SB-10054998-4055

Title: 8600 Front Spring Shackle Contacting Fuel Tanks**Applies To: 8600 TranStar Models Only****DESCRIPTION**

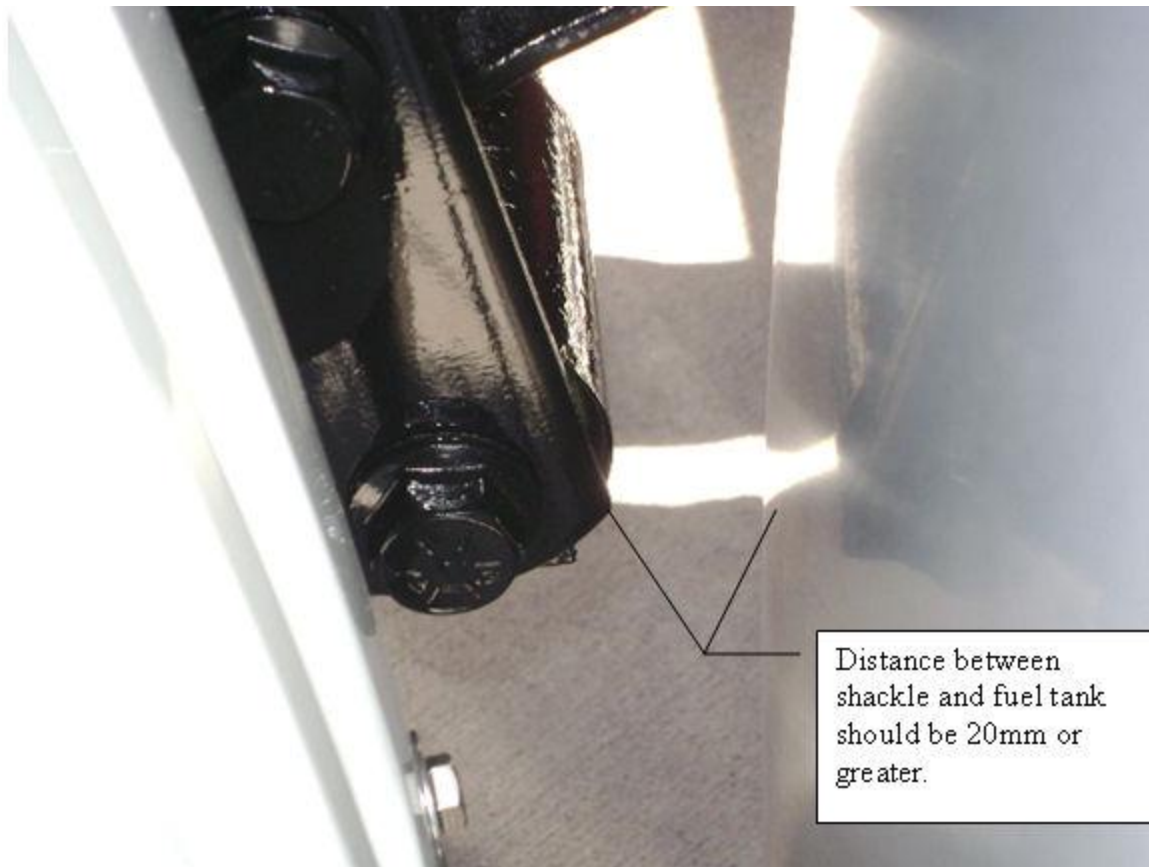
Rear shackle of steer axle spring suspension contacting fuel tank when unit is in use

Damage to fuel tank.

1. Verify that there is a least 20mm or more of clearance between the spring shackle and front of fuel tank
